## CITY COUNCIL AGENDA ITEM

Subject: PUBLIC HEARING – PRELIMINARY SITE PLAN REVIEW (File Number SP2021-0020) – Proposed Adler Cove (One Family Residential Cluster), South side of Long Lake, East of John R (Parcels 88-20-13-100-012, 88-20-13-100-014 and 88-20-13-100-025), Currently Zoned R-1C (One Family Residential) Zoning District

<b>Project Name:</b>	Alder Cove
<b>Plan Date:</b>	September 20, 2021
<b>Location:</b>	South of E. Long Lake, east of John R.
<b>Zoning:</b>	R-1C, One-family Residential District
<b>Action Requested:</b>	Preliminary Site Condominium Cluster Approval
<b>Required Information:</b>	Deficiencies noted.

Setbacks for non-cluster (underlying R-3 zoning) as compared to cluster development

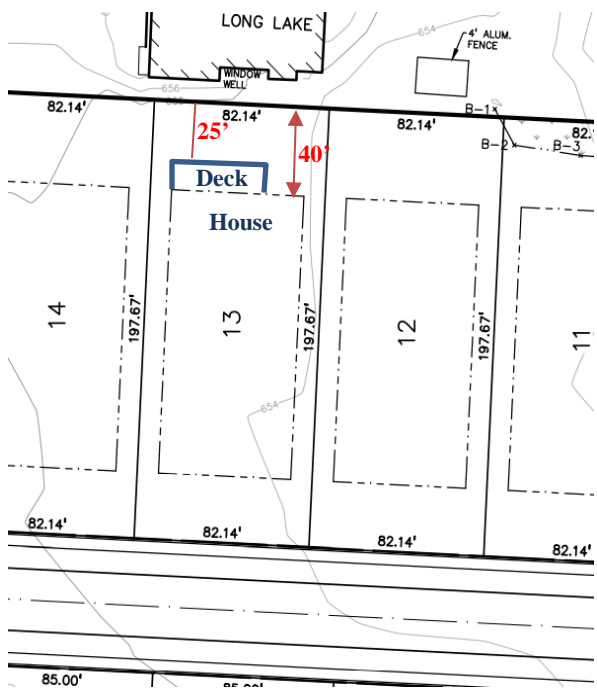
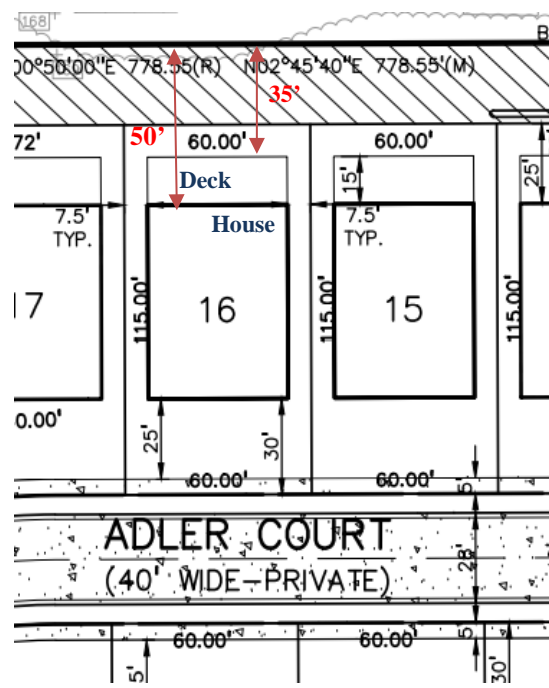
<b>Rear Setback (building)</b>	25-feet setback	25-feet minimum 10-feet with deck	Building envelopes comply. Decks encroach 15-feet into required rear yard. Applicant seeking relief to have minimum rear yard less than 25-feet due to deck.
<b>Side Setback (building)</b>	7.5-feet setback	7.5-feet minimum	Complies
<b>Open Space Requirements: Minimum Percentage</b>	20%	Proposing to preserve 3.8 acres of the 10.0 acres, or 38%, for open space.	Complies. Applicant must submit open space preservation covenant.

The applicant is showing decks on the rear of all properties. As set forth in Section 7.08.B:

The decks extend 15-feet from home and encroach 15-feet into the required 25-foot rear yard. Please note that provision 7.08.B was drafted for a conventional R 1 through R-5 lot that requires a 40-foot setback. Hence for a typical R-lot, the 40-foot rear yard requirement would allow a 15-foot deck and still maintain at least a 25-foot rear yard setback. However, due to the required additional perimeter setback required by the cluster provisions, the decks are further away from the northern property line via cluster than conventional layout. See graphic below:

Conventional R-3 layout, with decks 25-feet and house 40-feet from northern property line,

Proposed cluster layout with decks 35-feet and house 50-feet from northern property line

The City Council, based upon a recommendation from the Planning Commission, may waive the rear lot and perimeter setback provisions provided that the applicant has demonstrated innovative and creative site and building designs and solutions, which would otherwise be unfeasible or unlikely to be achieved absent this provision. The Planning Commission should consider the purpose and intent of the Cluster Development option in considering the setback deviations.
